# UNITED STATES PATENT AND TRADEMARK OFFICE

APPLICATION NO.	FILING DATE	FIRST NAMED INVENTOR	ATTORNEY DOCKET NO.	CONFIRMATION NO.
10/760,998	01/20/2004	Fang-Bin Liu	250210-1040	1645

## Office Action Summary

FIG. 1a (PRIOR ART)

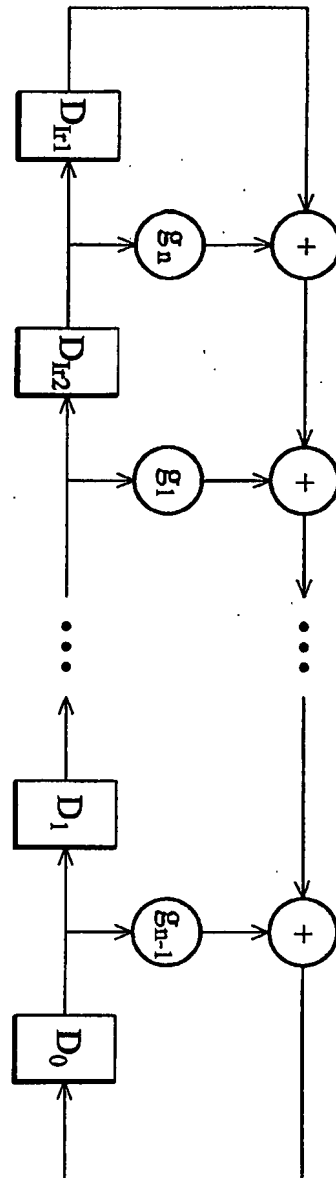
FIGs. 1A and 1B are amended herein by adding the designation of "Prior Art" to the figure labels.
